**CITY OF MILL CREEK
DESIGN REVIEW BOARD
APPLICATION PL2019-0016**

NAME OF PROJECT: Kazziep Short Plat

PROPOSAL: Review of roadway buffer landscaping.

Revision Description	No.	Date
Issue Date	10/11/2019	PERMIT/DRB
Project No.		
Designed By	TSP	Drawn By
Checked By	NFG	Checked By
LAND PLAN T (425) 275-9808 3151 Russet Road Brier, WA 98036		
KAZZIEP SHORT PLAT MILL CREEK, WA LANDSCAPE PLAN		
L-10

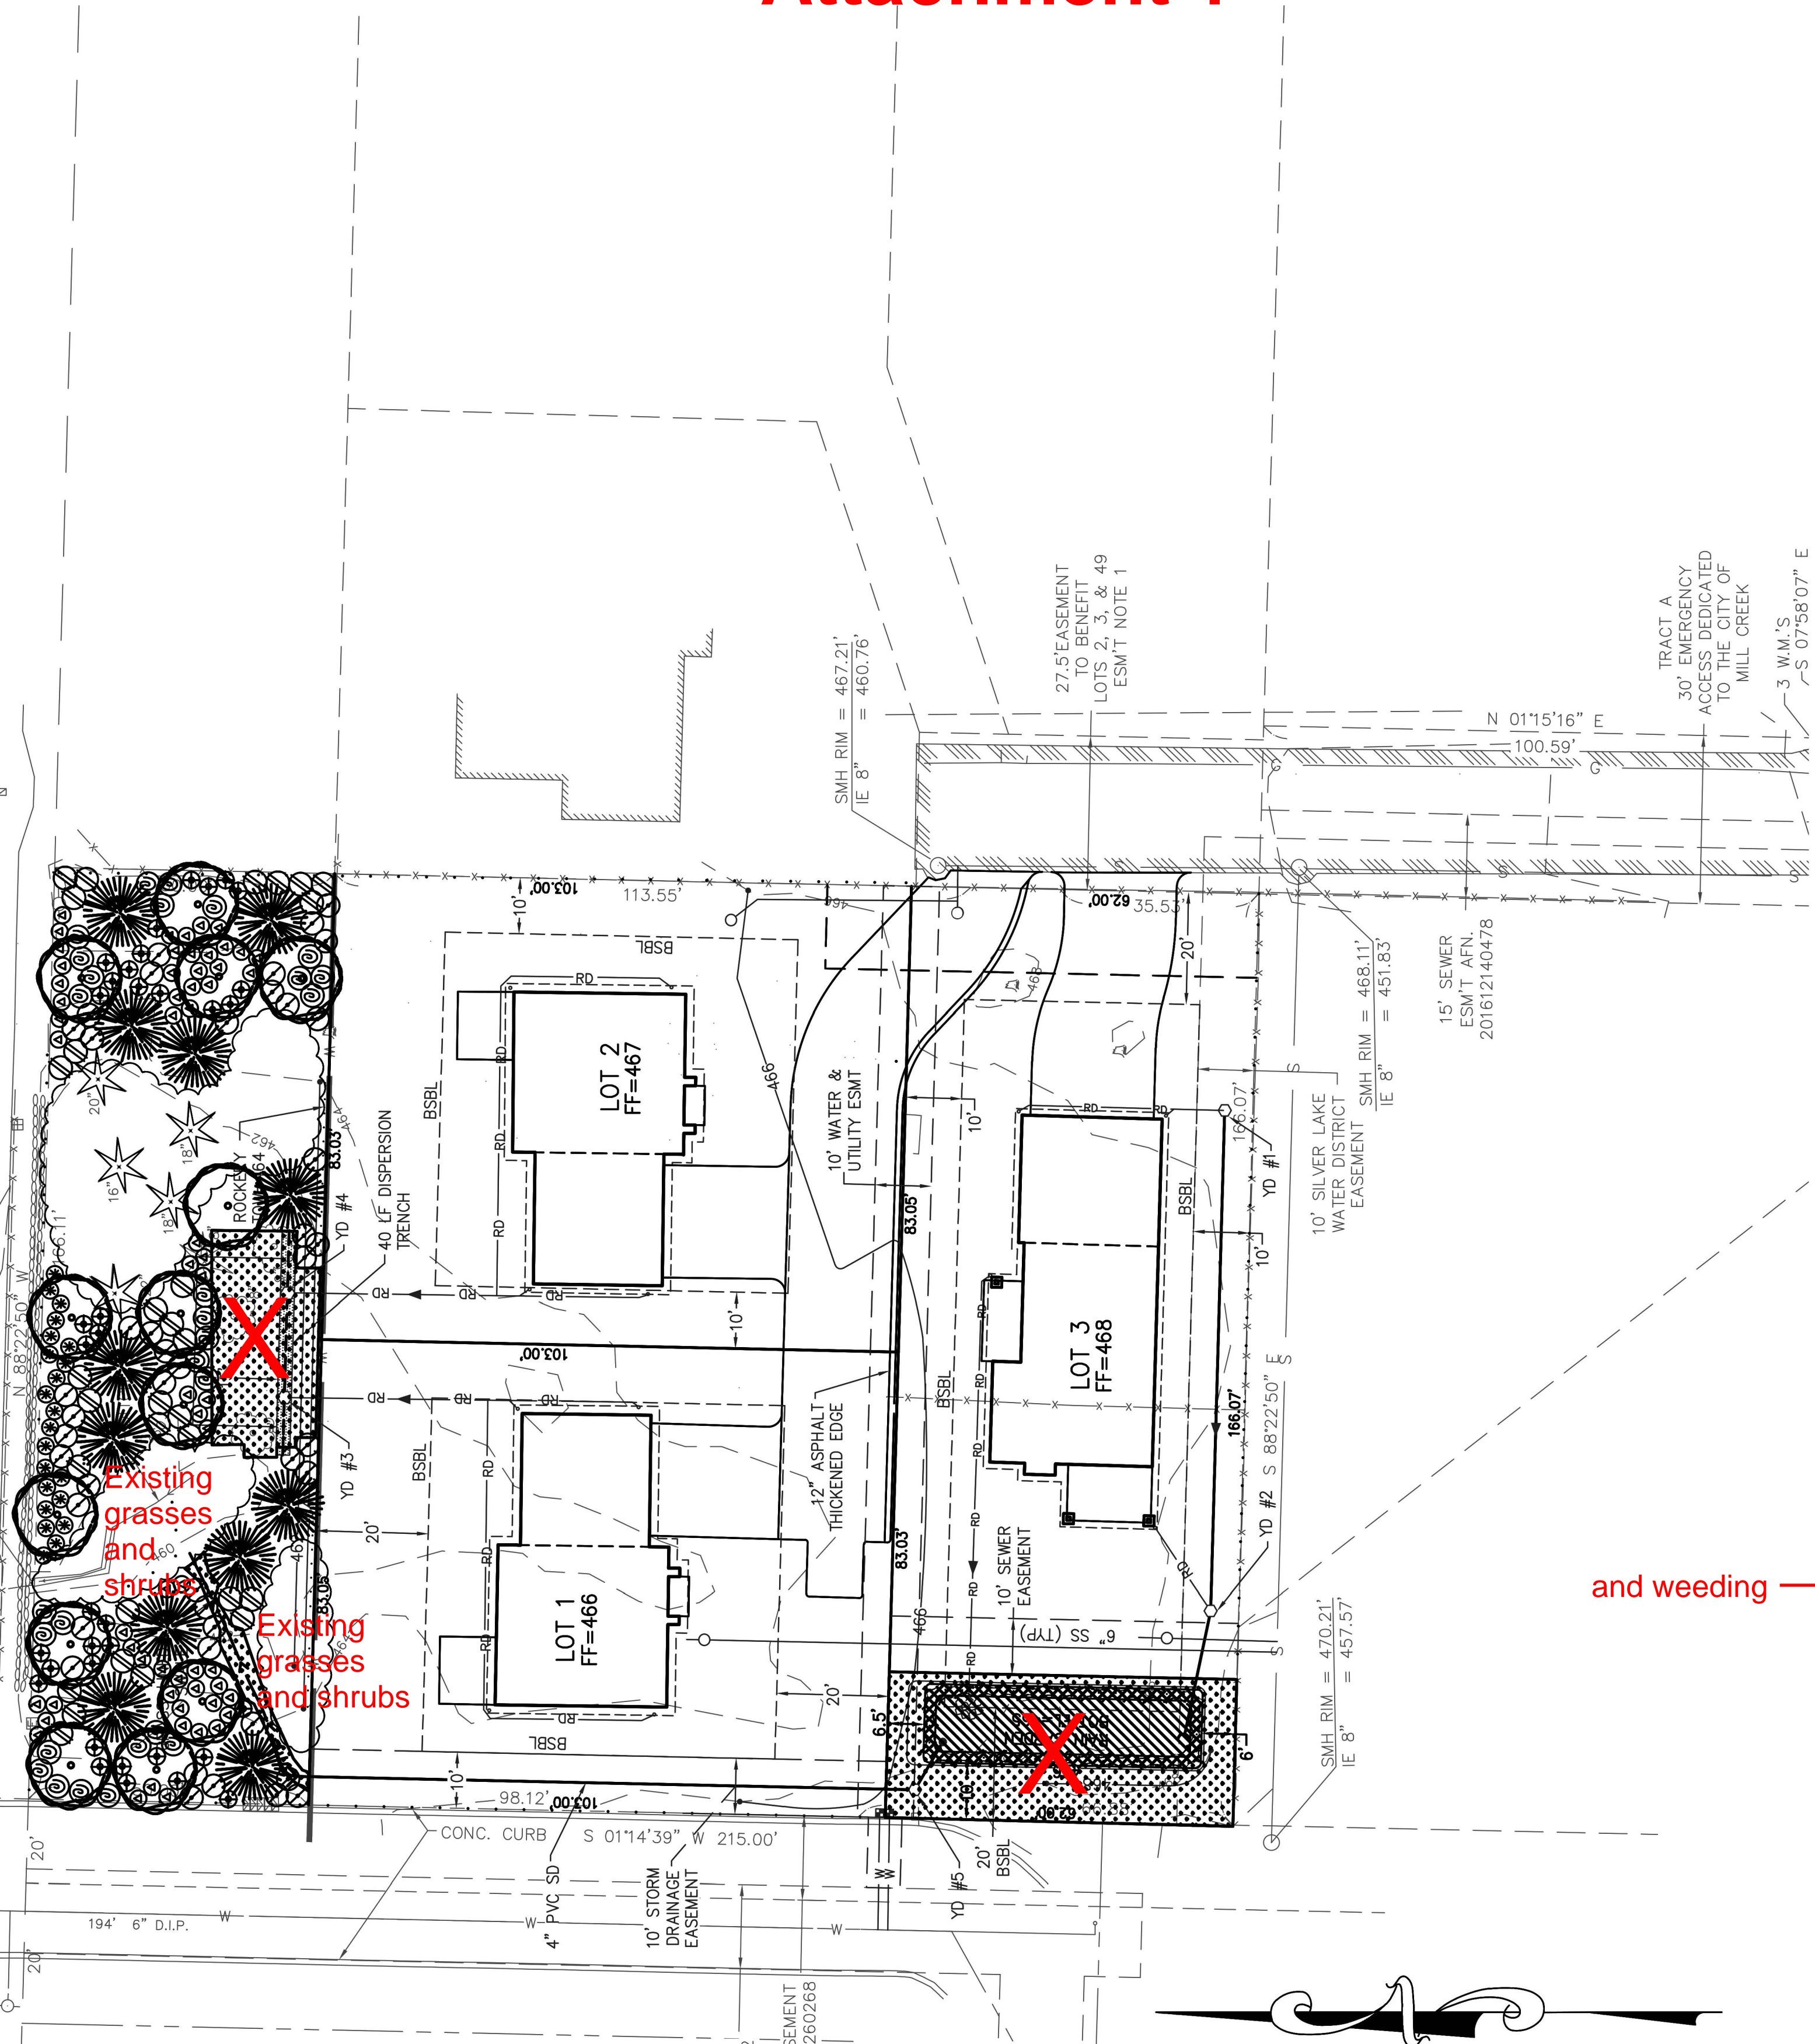
Rain gardens are subject to administrative review and are excluded from this review. So the rain garden are "crossed-out" on all attachments.

Attachment 2

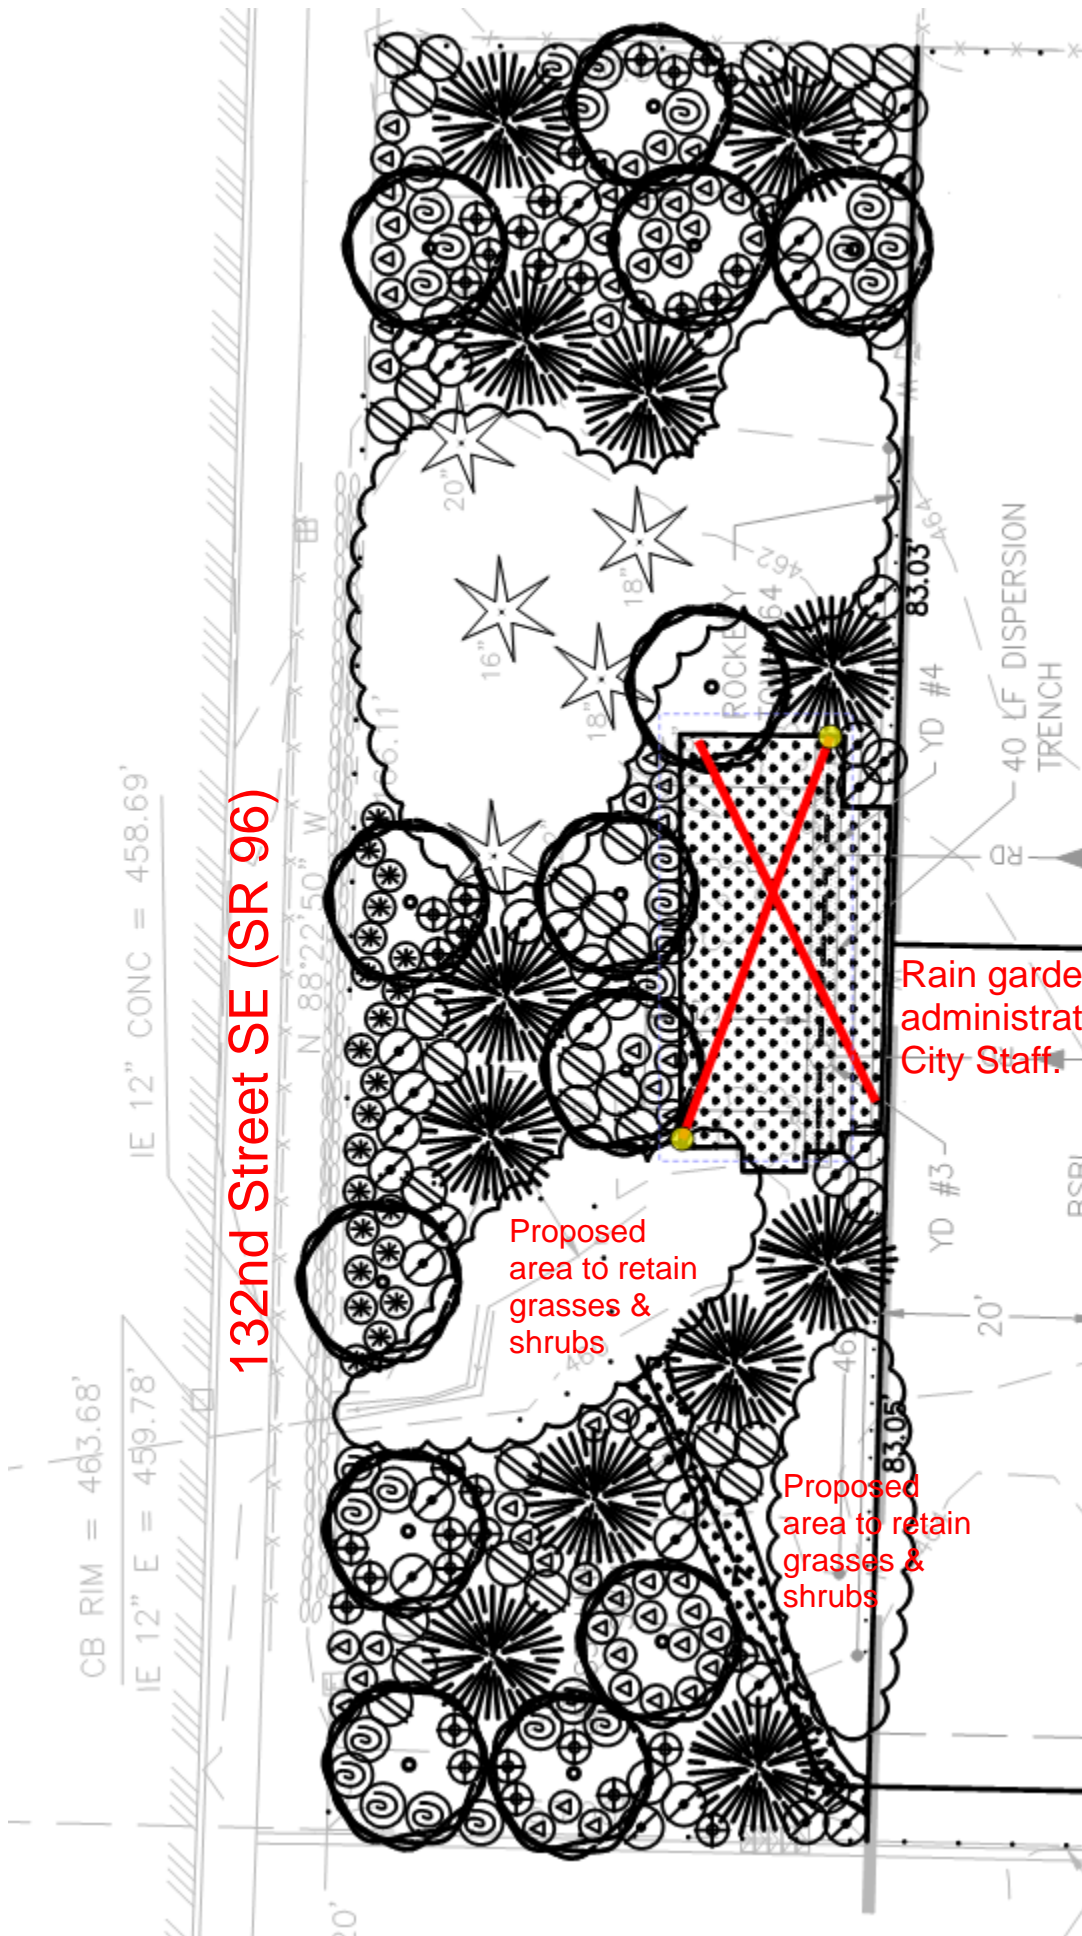
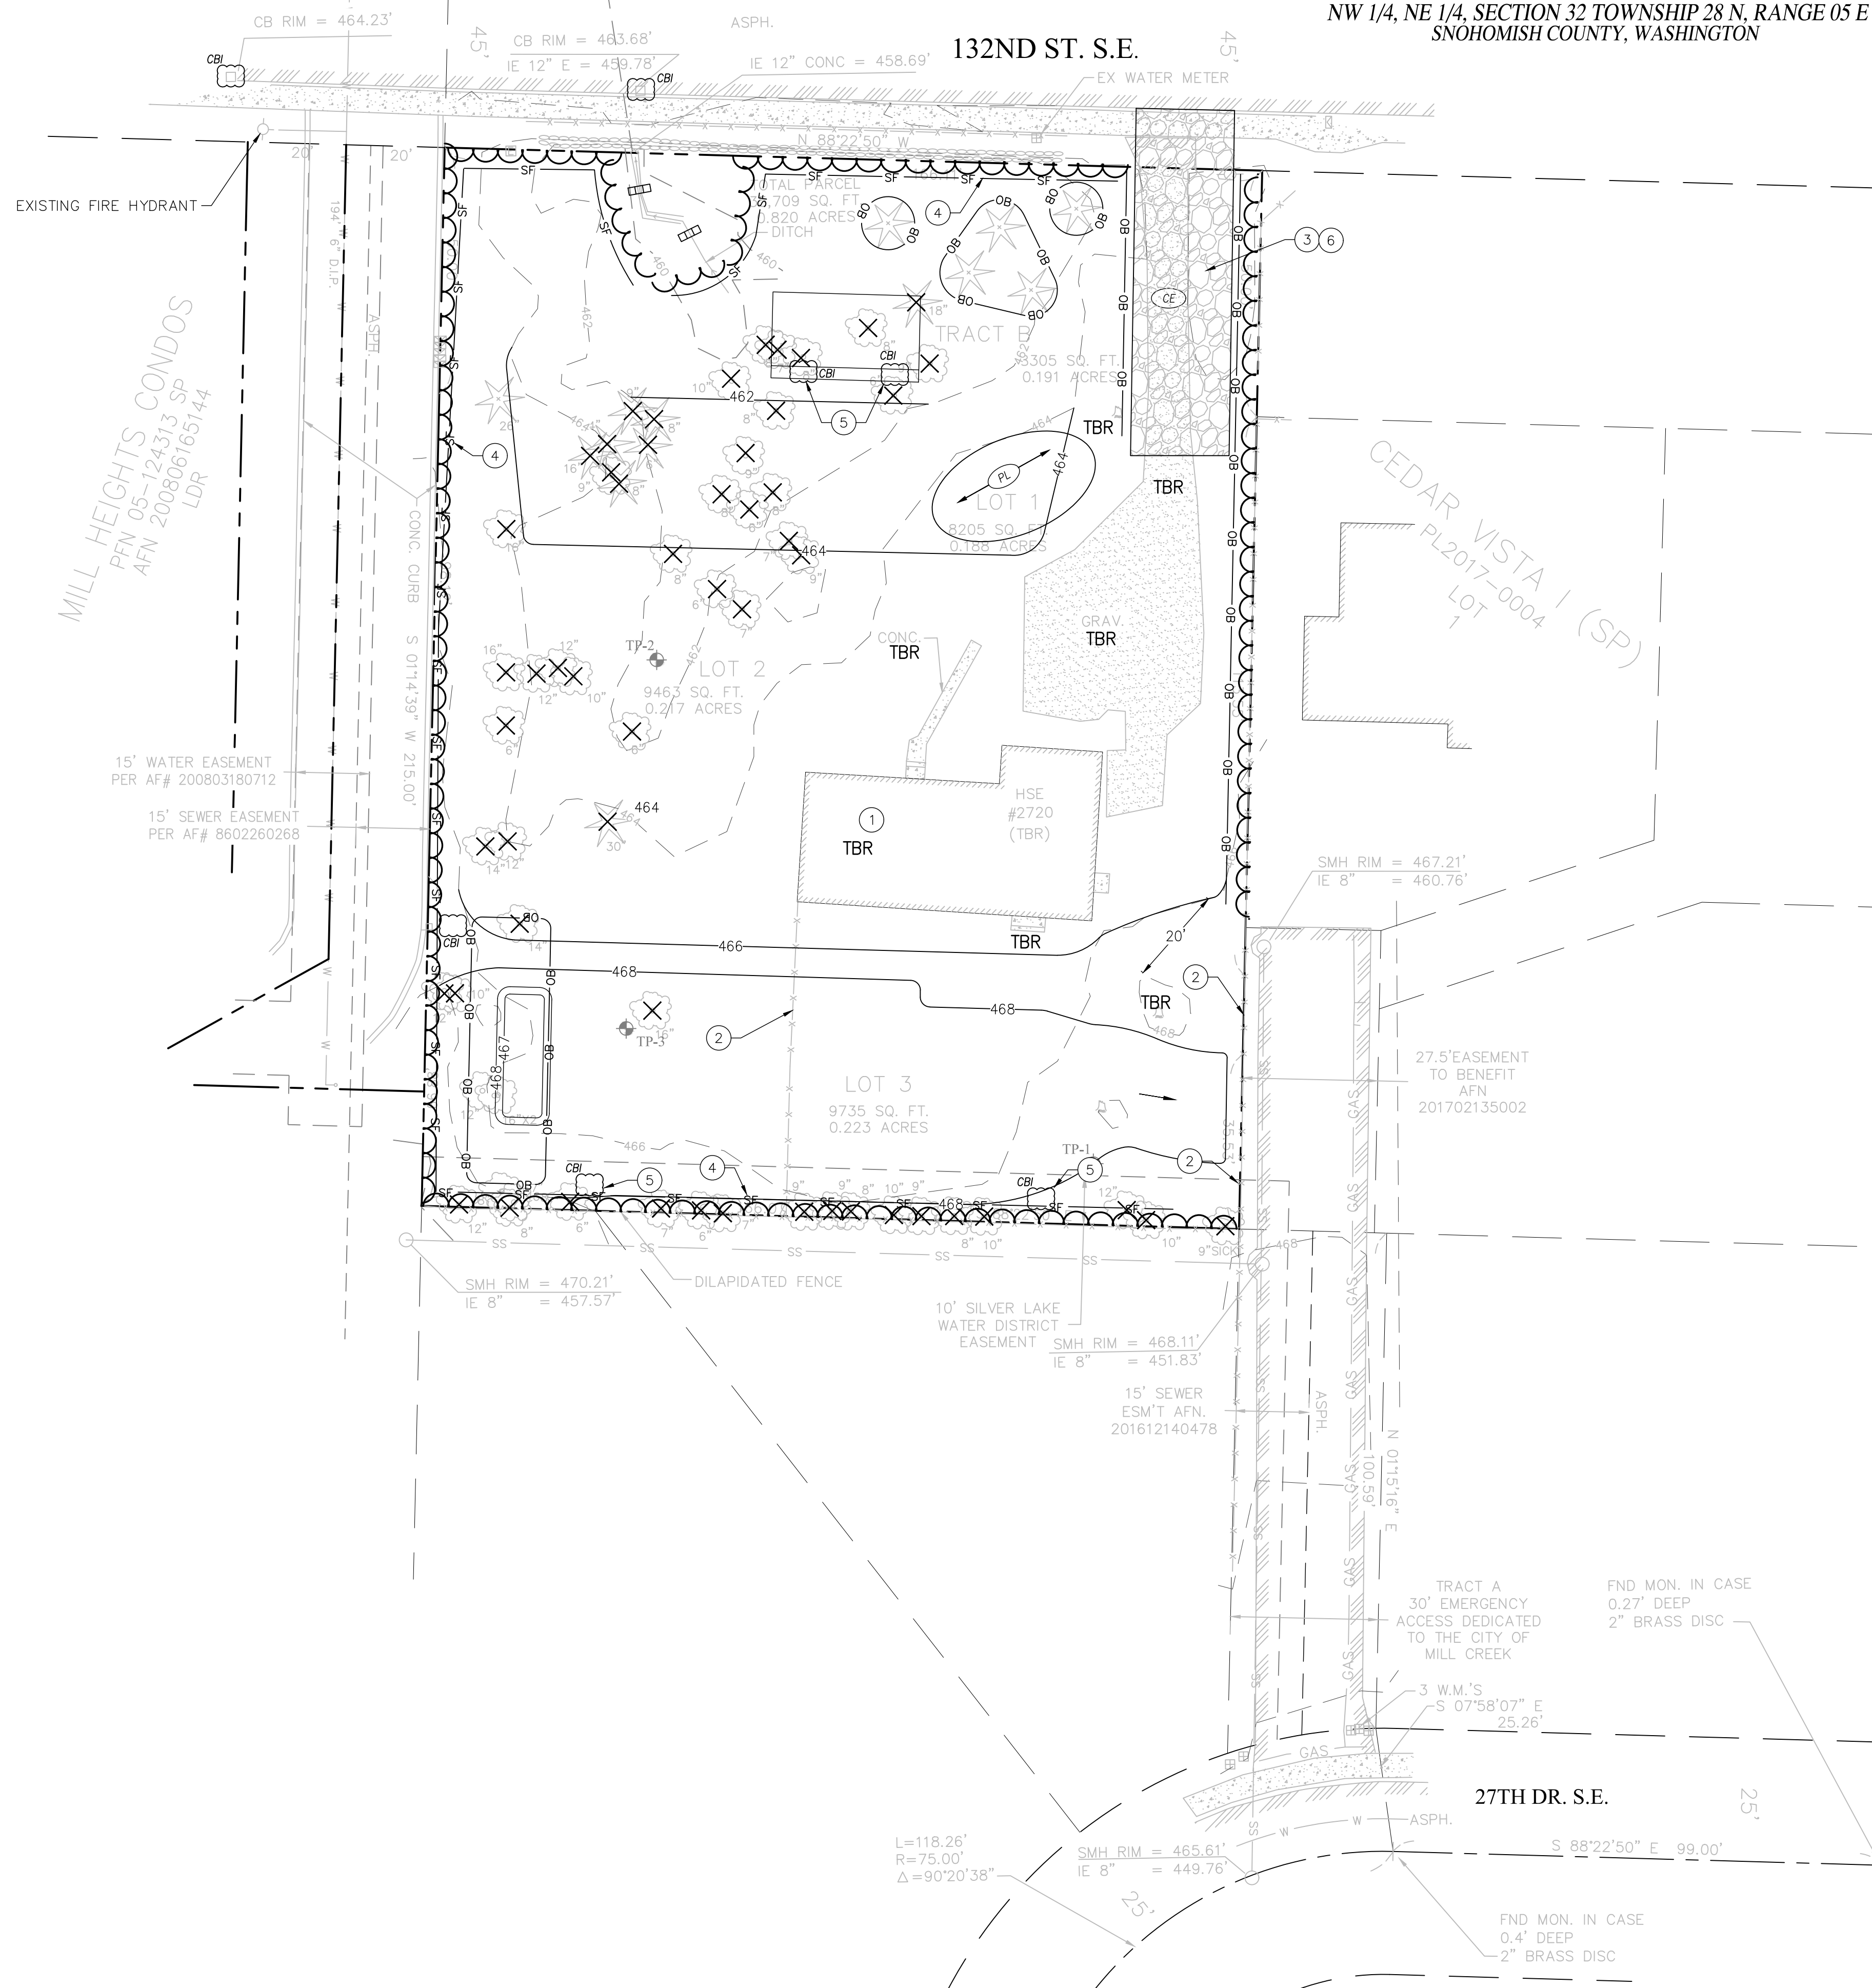
If the plant health is poor plants will be replaced with other specie from plant list

1. The plant materials and design shall be as portrayed in the application with the following condition: Once the buffer has been cleared of all vegetation being removed, the applicant shall schedule a site inspection with staff to determine if the quality and health of the shrubs and grasses, identified to be retained, are worth retaining and if not identify plants from the approved plant list to be planted instead.
